S4.55 LIST OF AMENDMENTS:

MCD2020/0139
BASEMENT
NO 3 RL 11.34

PROJECT
THREE STOREY RESIDENTIAL FLAT BUILDING
WITH BASEMENT CAR PARK AT:

5 COMMONWEALTH PDE,
MANLY, NSW

DRAWING TITLE
BASEMENT PLAN

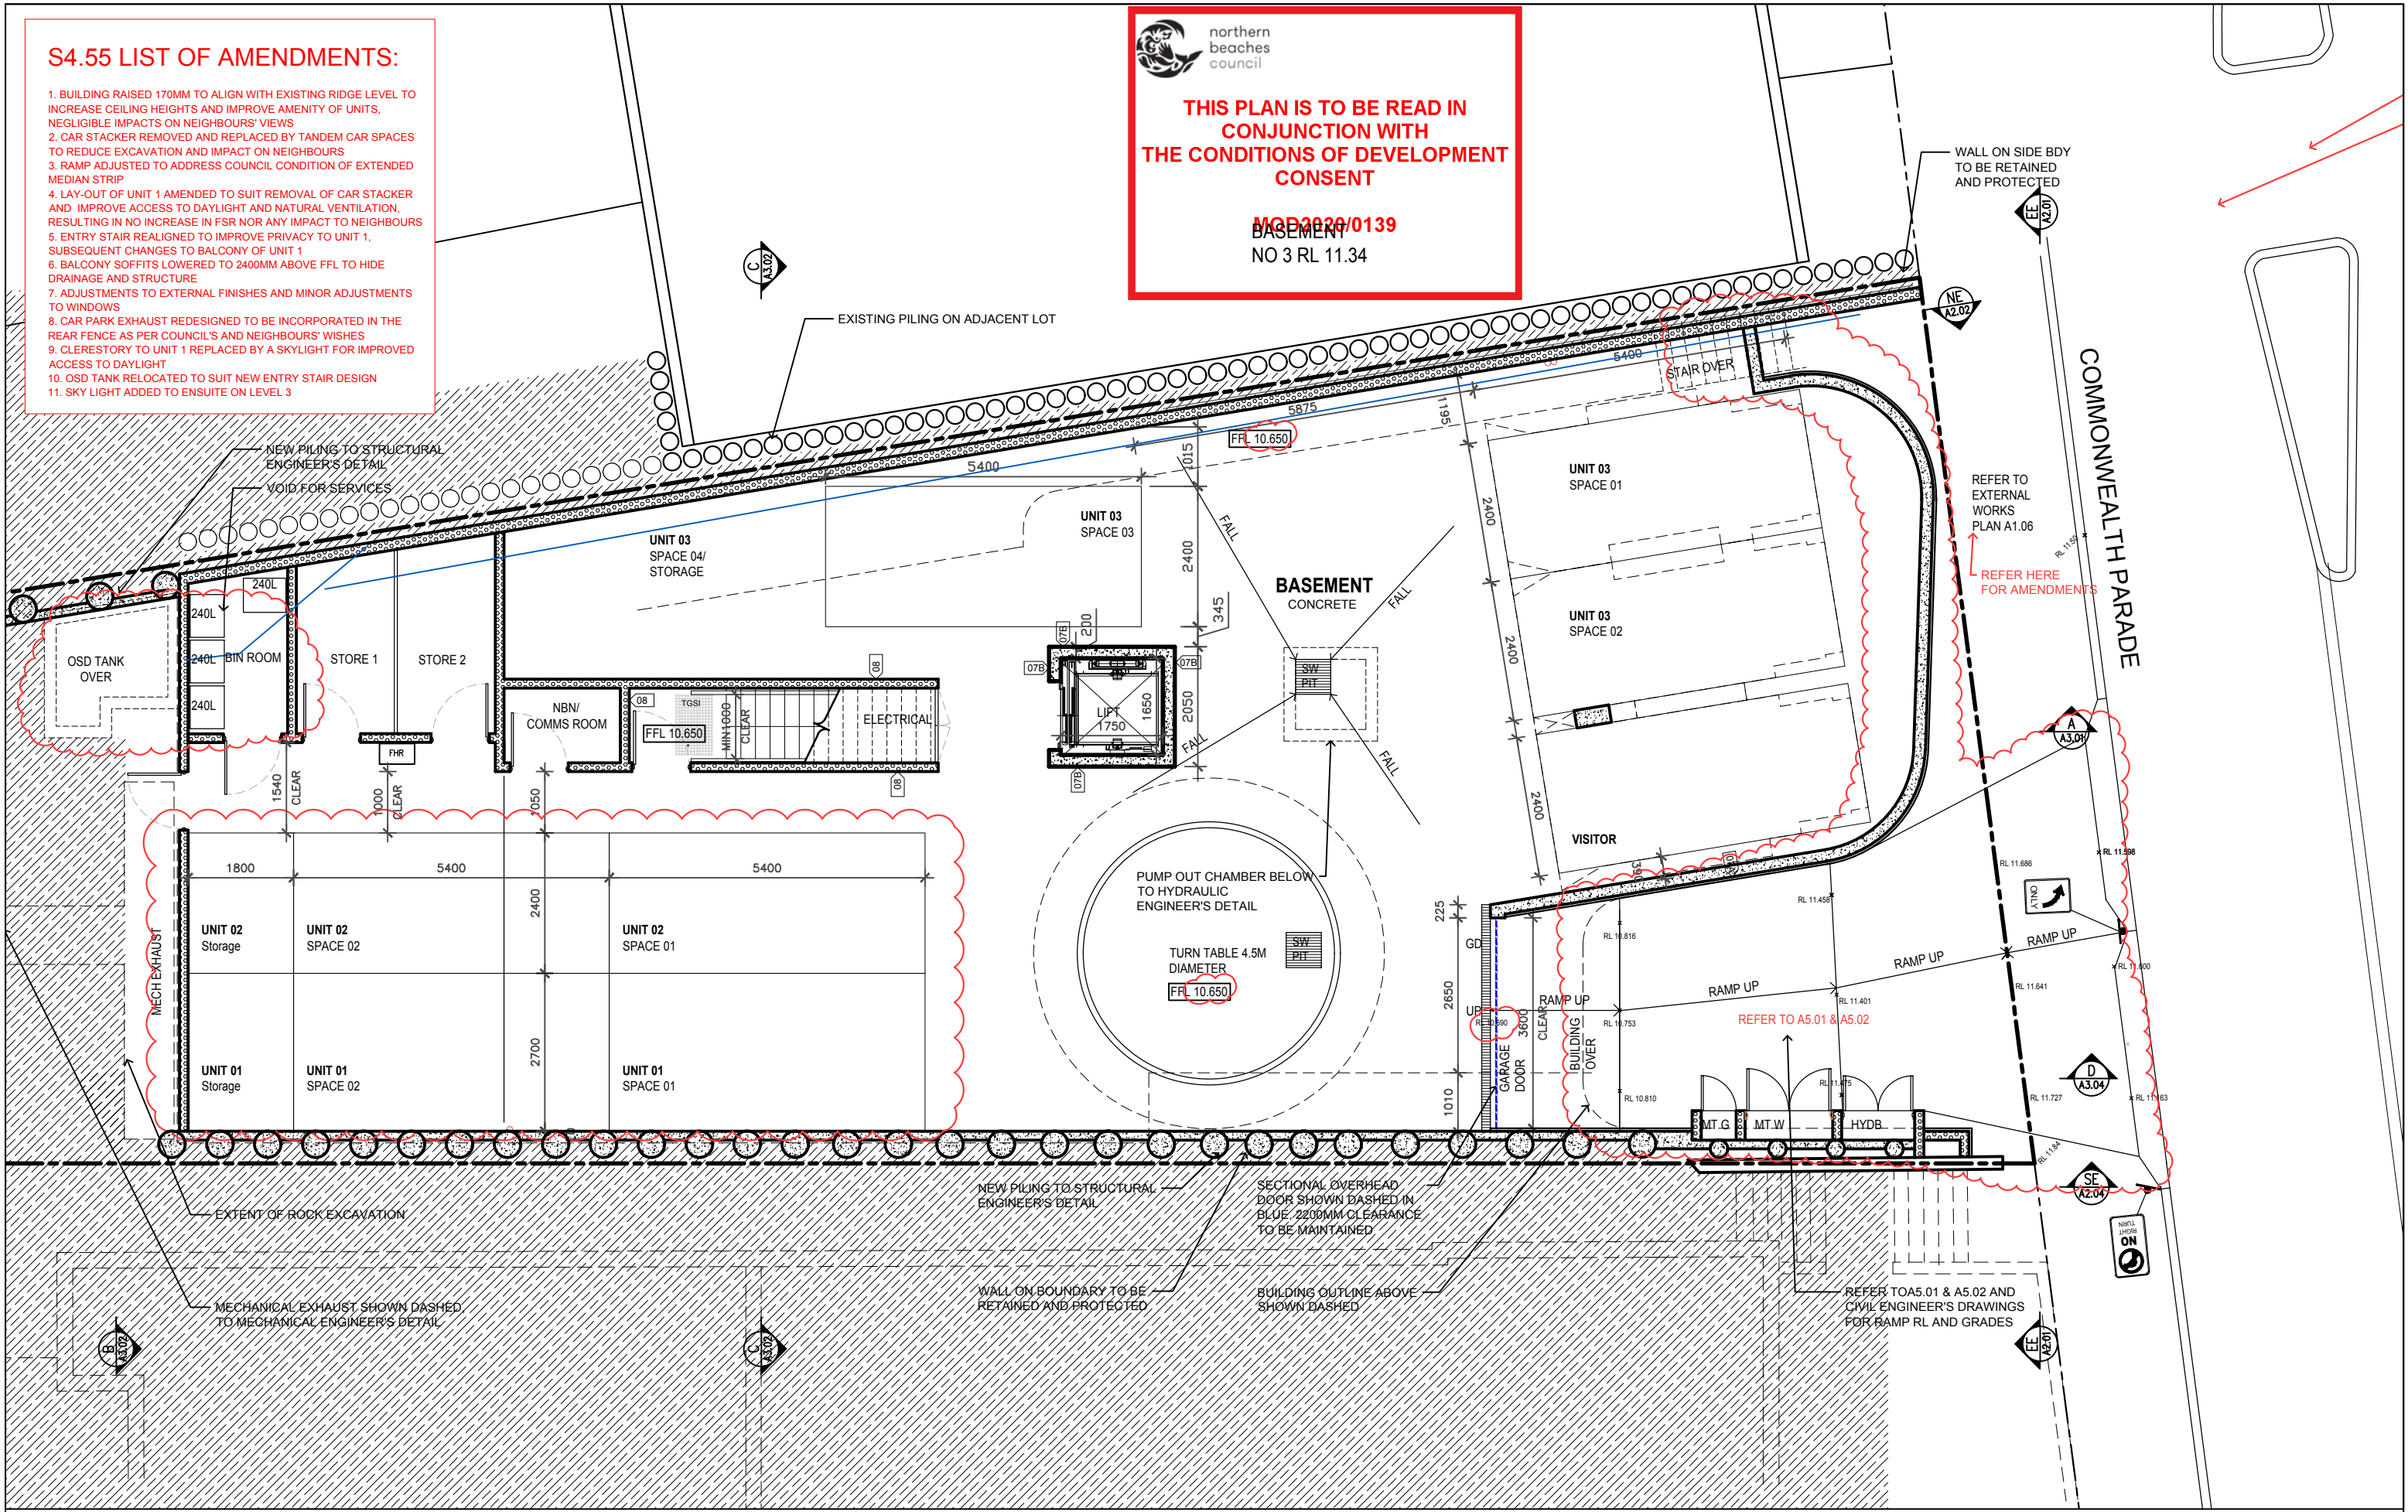
2. CAR STACKER REMOVED AND REPLACED BY TANDEM CAR SPACES TO REDUCE EXCAVATION AND IMPACT ON NEIGHBOURS
3. RAMP ADJUSTED TO ADDRESS COUNCIL CONDITION OF EXTENDED MEDIAN STRIP

9. CLERESTORY TO UNIT 1 REPLACED BY A SKYLIGHT FOR IMPROVED ACCESS TO DAYLIGHT
10. OSD TANK RELOCATED TO SUIT NEW ENTRY STAIR DESIGN
11. SKY LIGHT ADDED TO ENSUITE ON LEVEL 3

DRAWING TITLE
NORTH ELEVATION

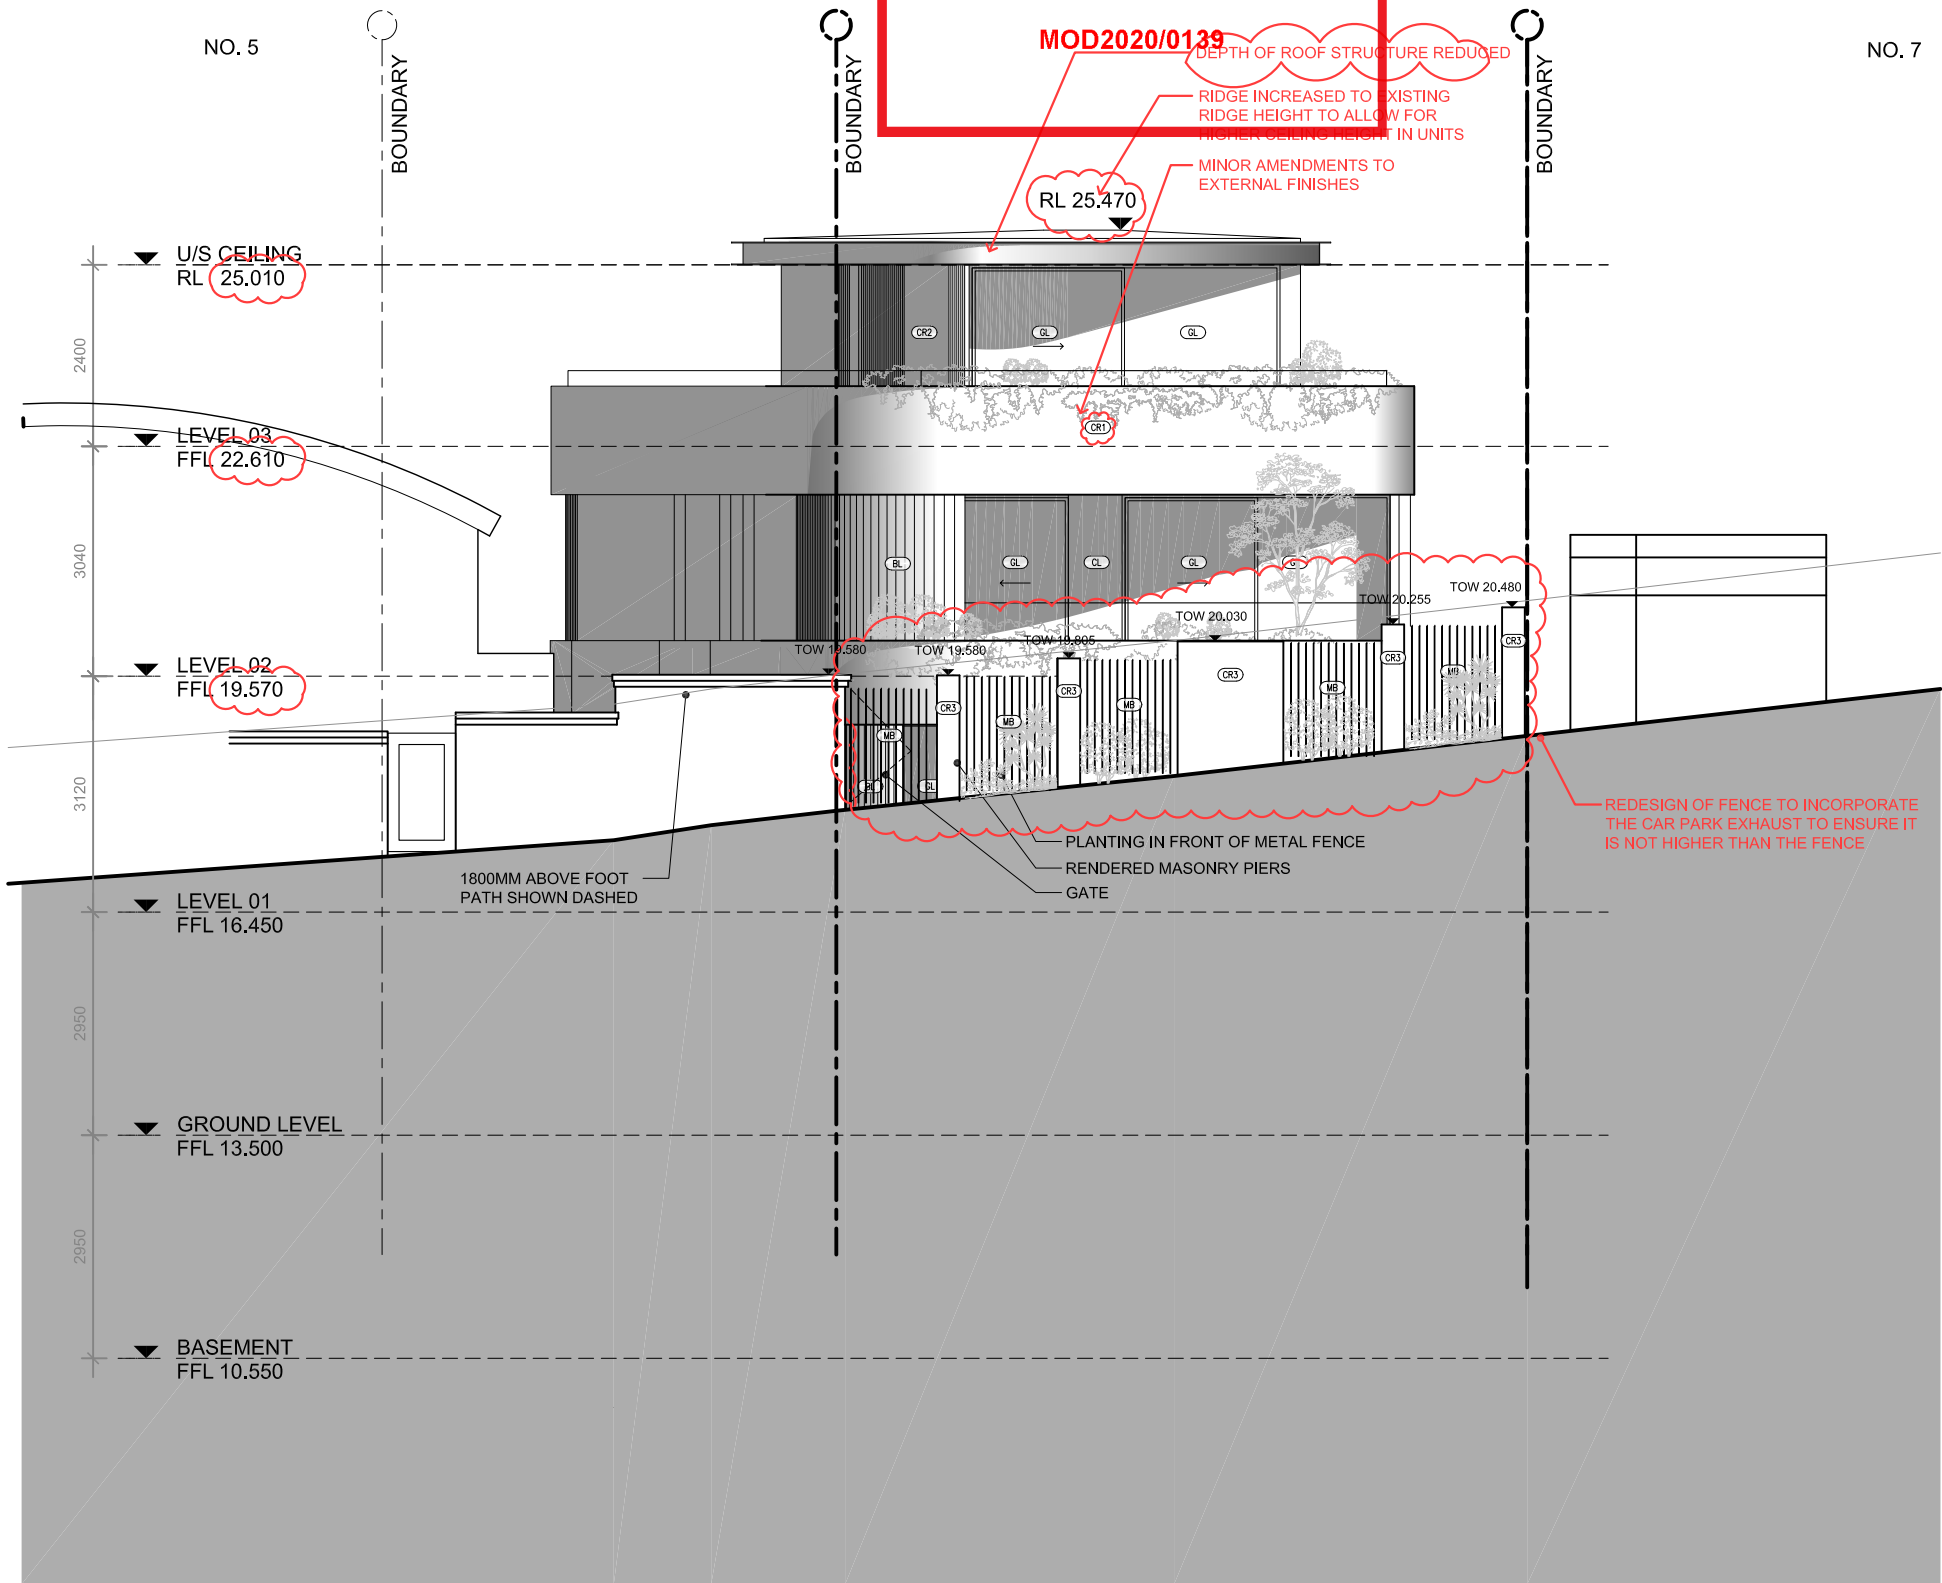
DEPTH OF ROOF STRUCTURE REDUCED

RIDGE INCREASED TO EXISTING RIDGE HEIGHT TO ALLOW FOR HIGHER CEILING HEIGHT IN UNITS

MINOR AMENDMENTS TO EXTERNAL FINISHES

DRAWING TITLE
SECTION AA

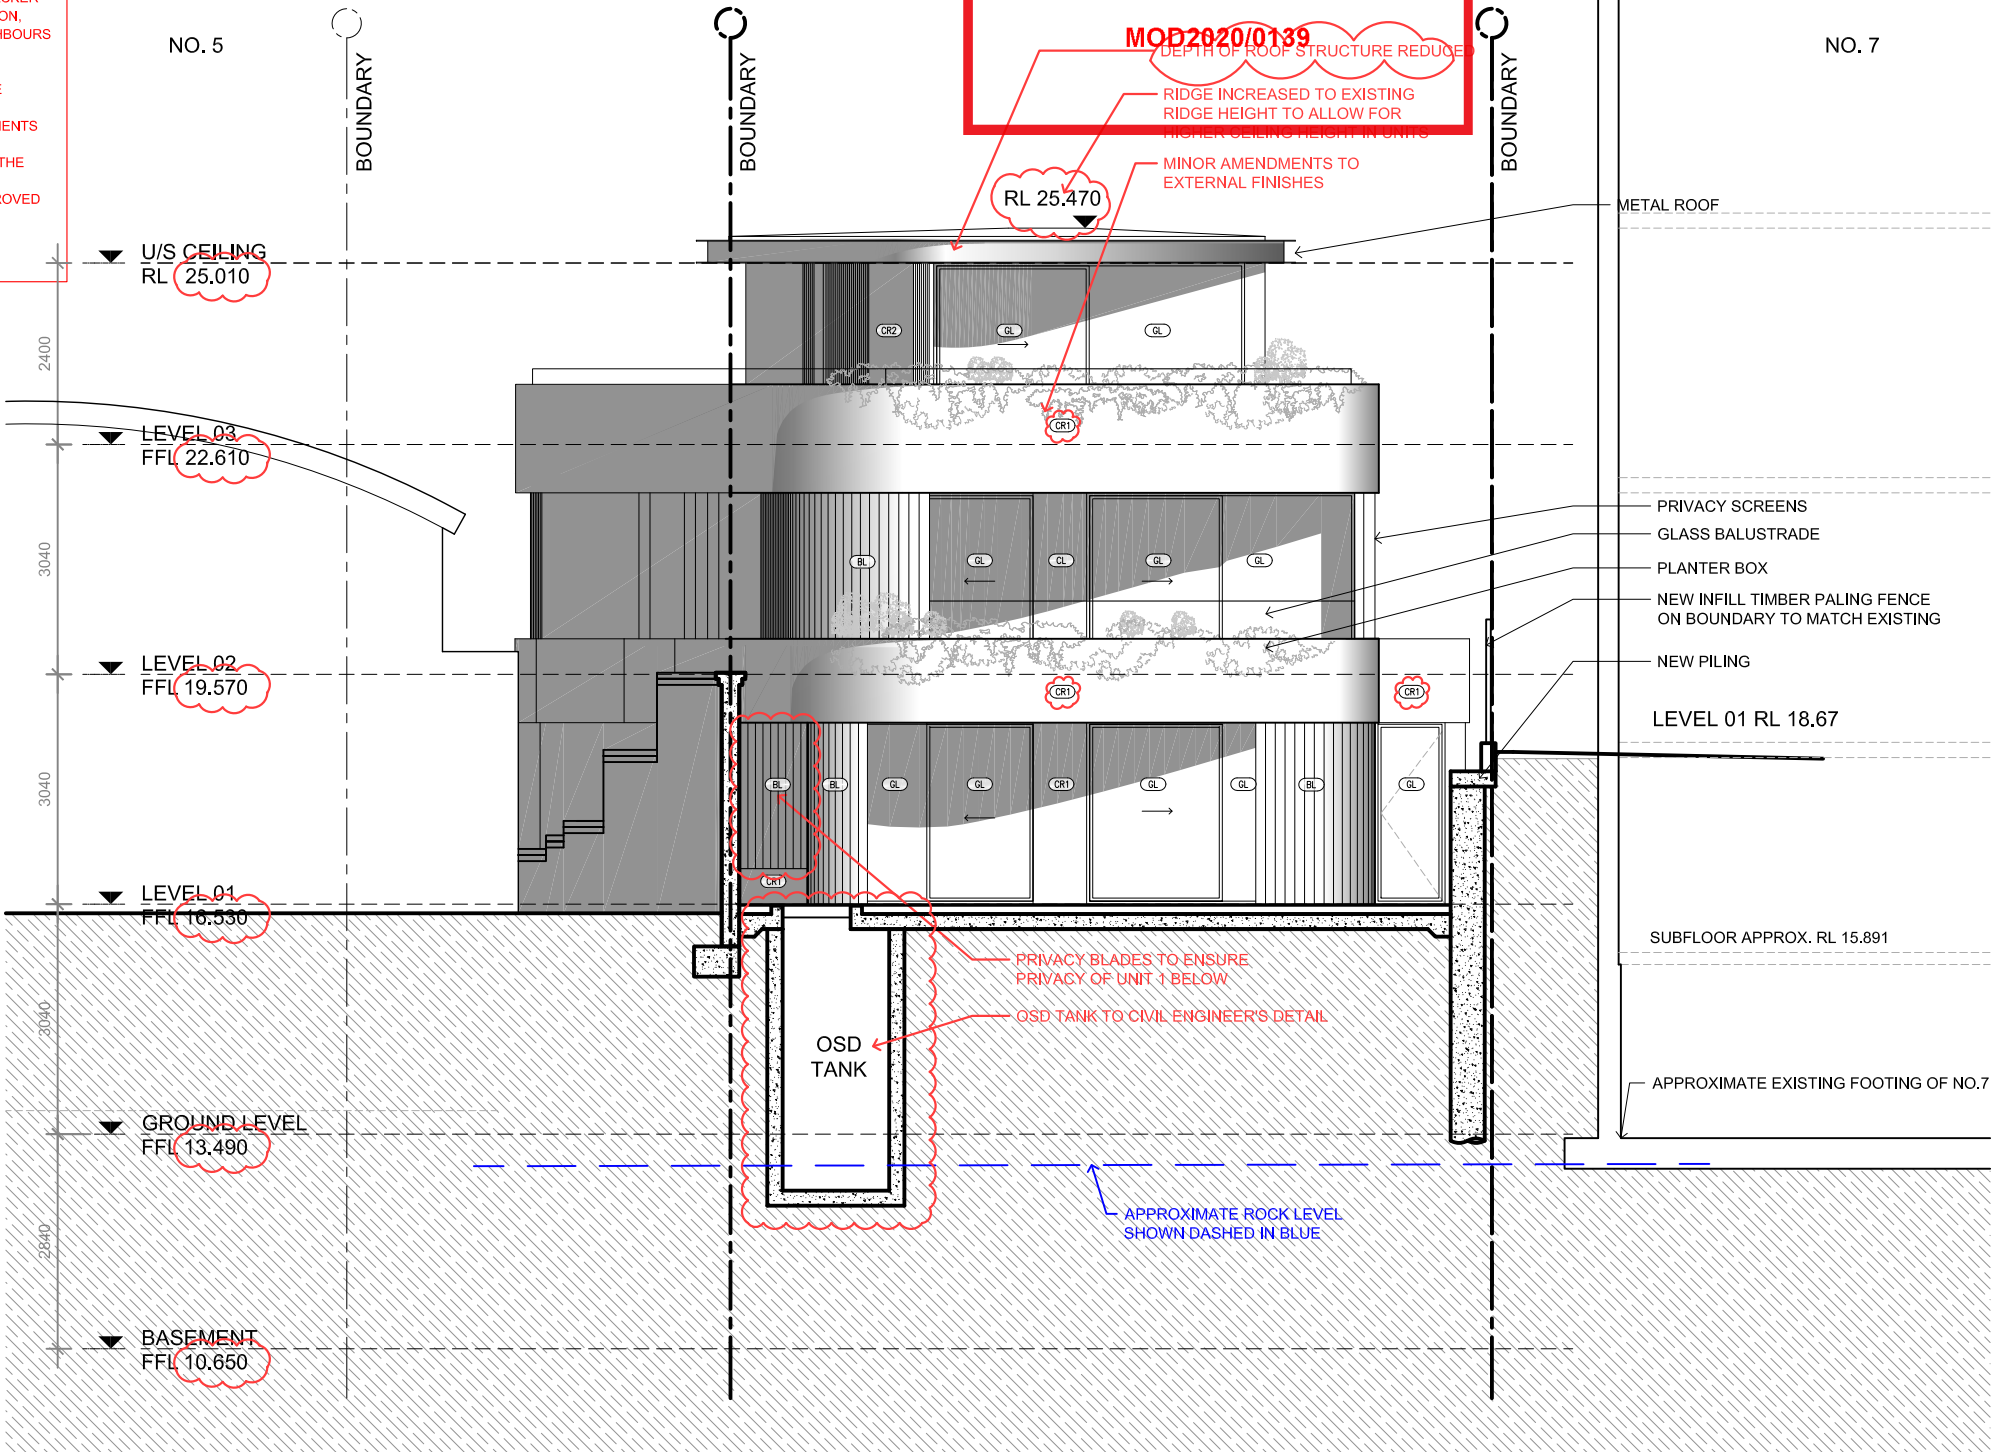
RIDGE INCREASED TO EXISTING RIDGE HEIGHT TO ALLOW FOR HIGHER CEILING HEIGHT IN UNITS

MINOR AMENDMENTS TO EXTERNAL FINISHES
